Subject ▶ Change on DC Motor

For Models ▶ DA391D, DA391DW, DA390D, DA390DW (Cordless angle drills)

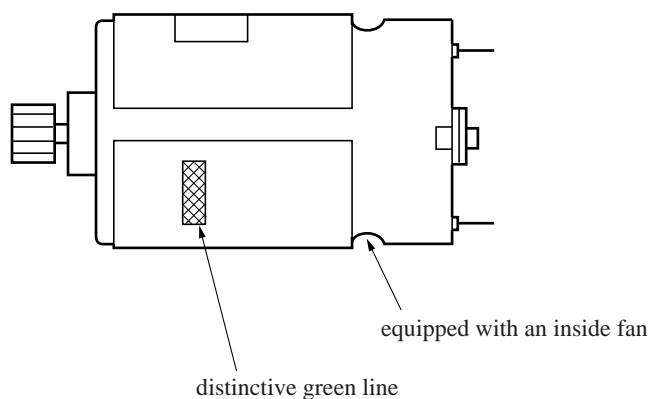
Description ▶ In order to conform to UL Standards, the current motor has been replaced by the new motor which is equipped with an inside cooling fan. This information applies to all the countries and areas.

Item No.	Current part		Q'ty	I/C	New part		Q'ty	Note
14	DC motor 629595-0		1	Yes	DC motor 629623-1		1	The current motor has been discontinued.

DA391D: From serial No. 637559E
DA391DW: From serial No. 59587E
DA390D: Discontinued since Oct., 1993
DA390DW: Discontinued since Oct., 1993
